# **AQUIND INTERCONNECTOR**

## **Applicant's Response to Deadline 4 Submissions**

Document Ref: 7.9.23

**DATE: 23 DECEMBER 2020**

TITLE: **FORT CUMBERLAND CAR PARK EXISTING LAYOUT**

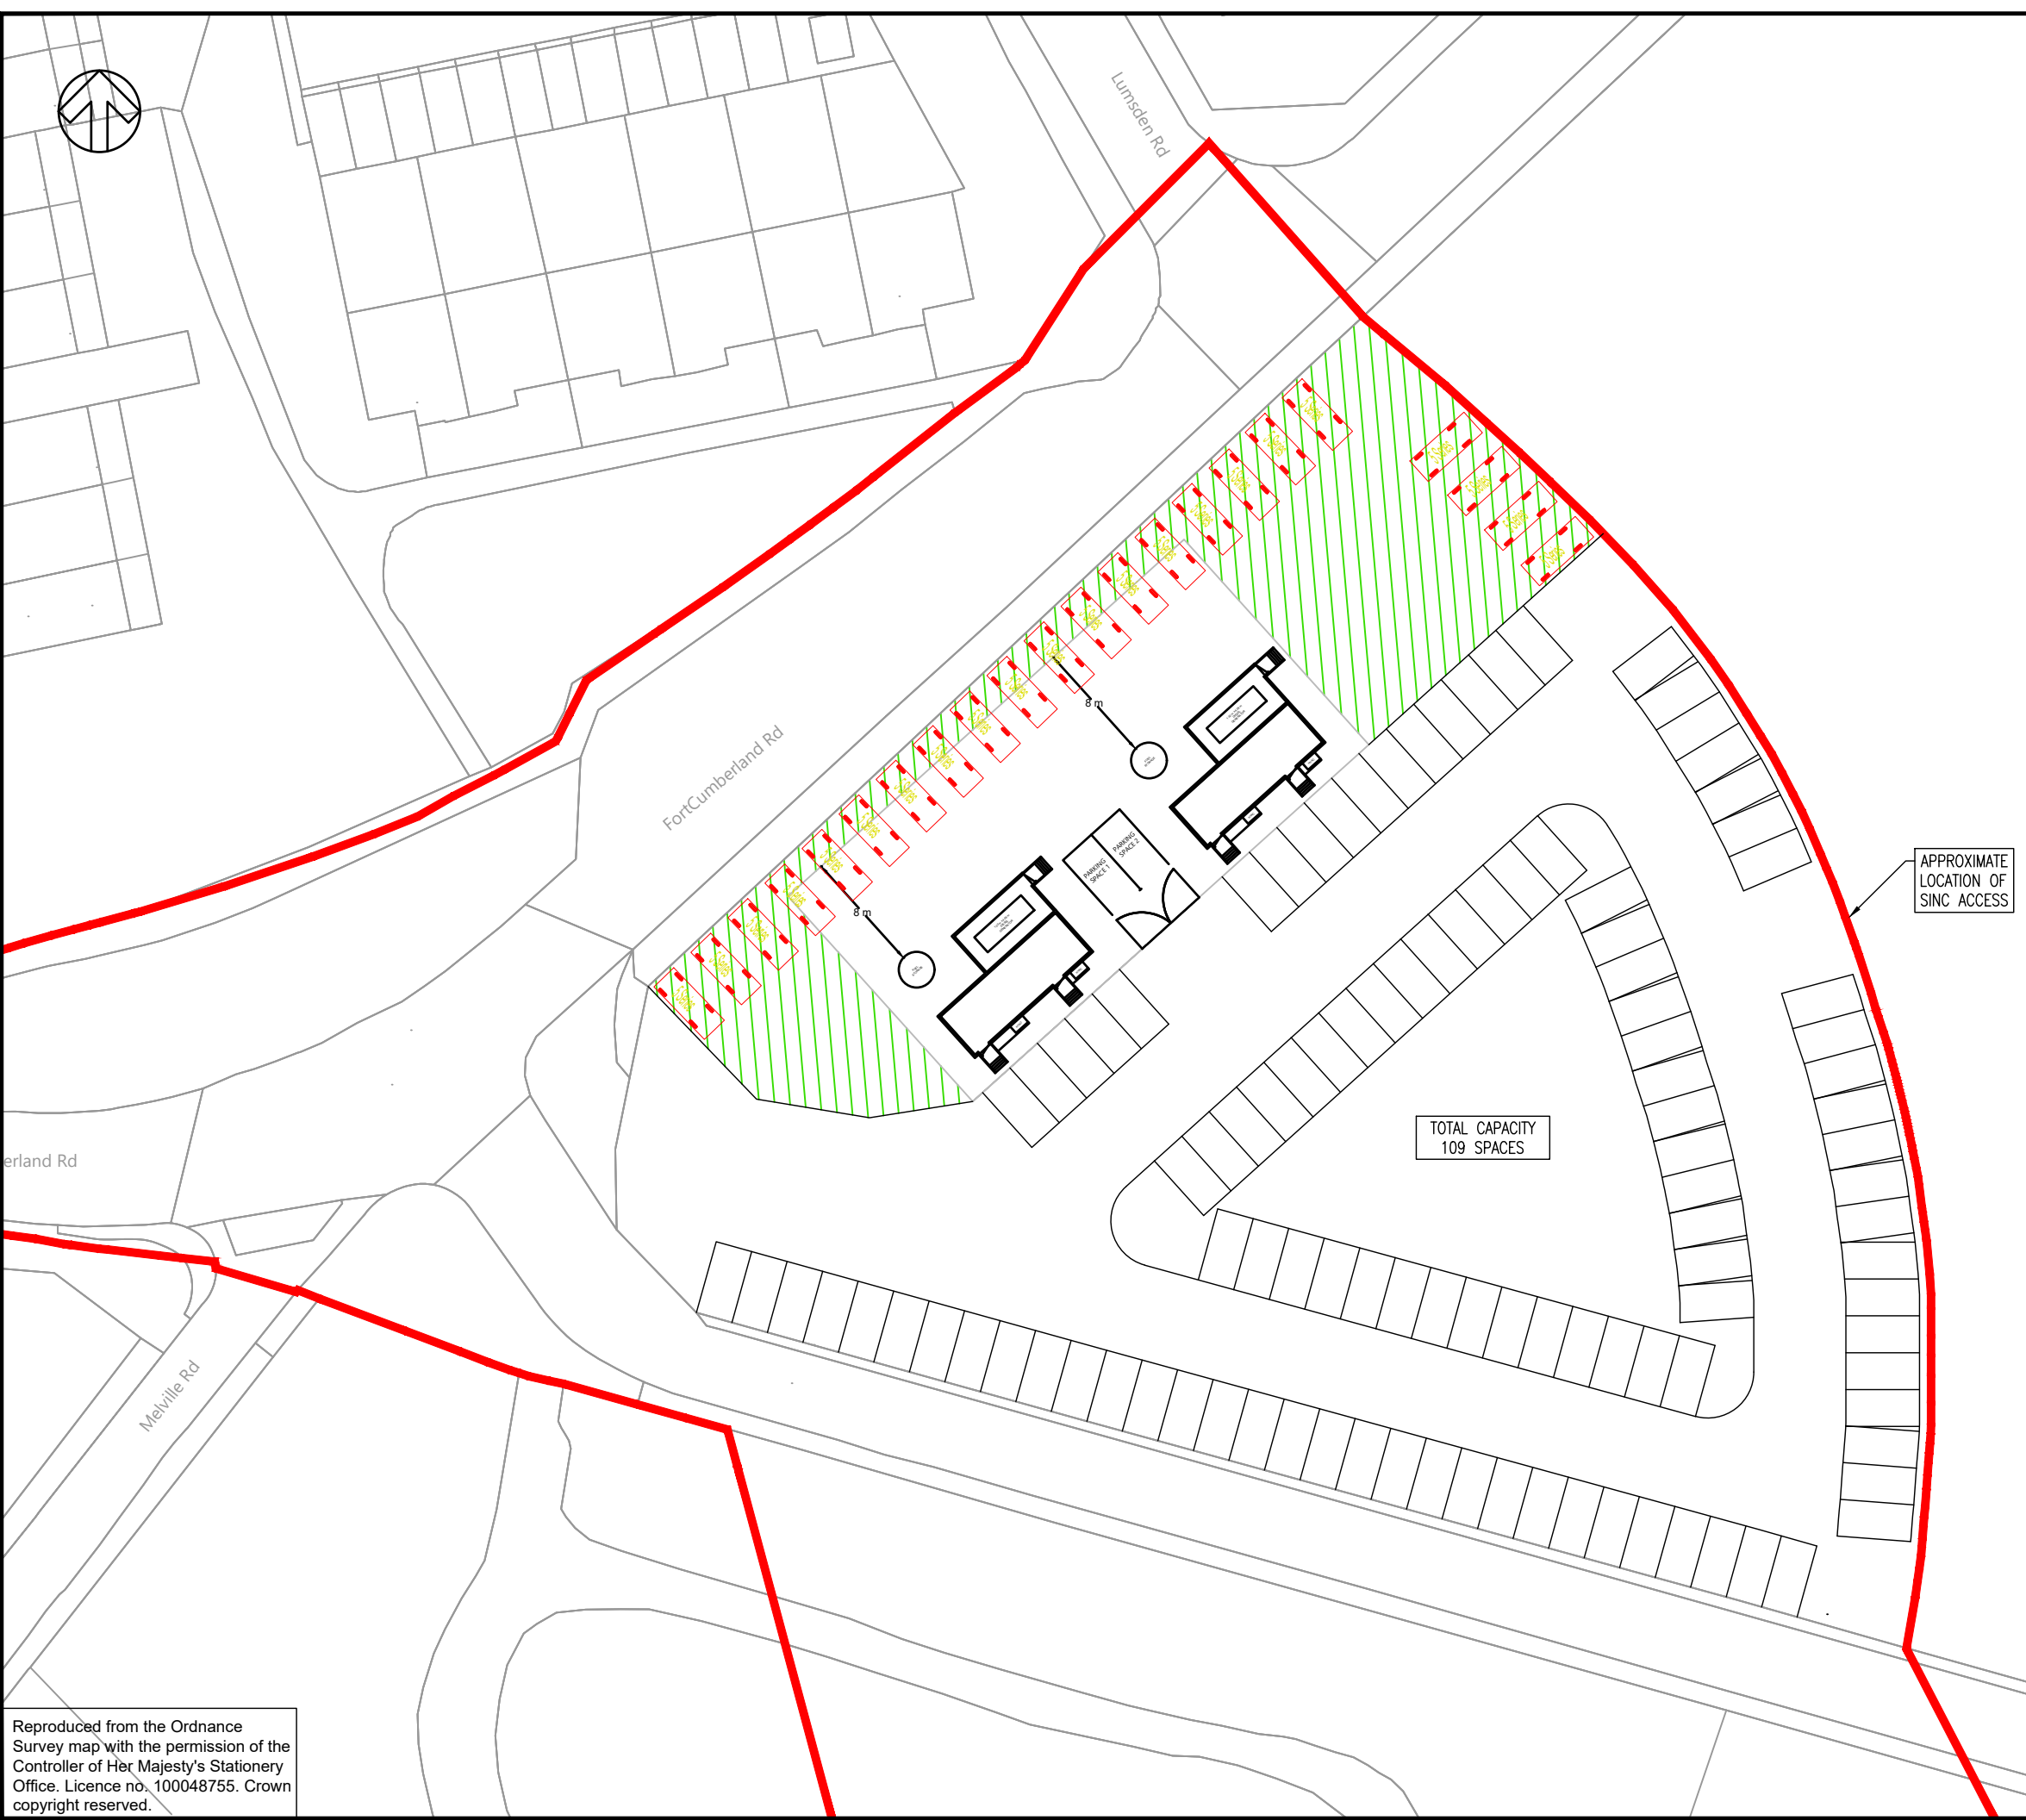
66-69	<p>With regards to the impact the proposed ORS building and the impact on Fort Cumberland Carpark, PCC raise the following concerns:</p> <ul style="list-style-type: none"> <li>• users of the car park will be displaced (due to the ORS building, screening and works) and thus PCC conclude that the users of the Open Space that the car park serves will be permanently displaced;</li> <li>• at paragraph 45 of the Applicant's Response to Deadline 2 Submissions, the Applicant confirms that there will be no permanent loss of playing fields following the installation of the cables, however, PCC consider that the permanent loss of car park space at Fort Cumberland has not been addressed;</li> <li>• as set out in PCC's case in respect of the proposed exercise compulsory acquisition powers, PCC disagrees that it would be lawful to include fibre optic cables and equipment as associated development for the purposes the Applicant is seeking and, therefore, consider that the displacement from the Fort Cumberland Carpark is unnecessary.</li> </ul>	<p>The Applicant is currently in discussions with PCC regarding proposals for post-construction mitigation measures which are intended to offset any impacts associated with the proposed ORS buildings in Fort Cumberland Car Park. It is intended that the proposed mitigation will provide as a minimum the same number of parking spaces as the existing layout provides. Mitigation measures which are currently being considered to re-provide the existing parking provision include resurfacing and provision of formal parking bays in the place of the existing informal layout of the Car Park (see Appendix F).</p> <p>Whilst discussions regarding this matter are currently ongoing, the Applicant understands that they would either undertake this work themselves or proposes that PCC undertakes this work on the Applicant's behalf and at the cost of the Applicant. In all cases, the Applicant will seek to agree any proposed mitigation at Fort Cumberland Car Park with Portsmouth City Council prior to its implementation.</p> <p>The principal requirement for the ORS in relation to the interconnector, as detailed in Section 2.2 of Statement in Relation to FOC (REP1-127) is to support the primary function in the amplification of the optical signals to ensure the quality of signal</p>
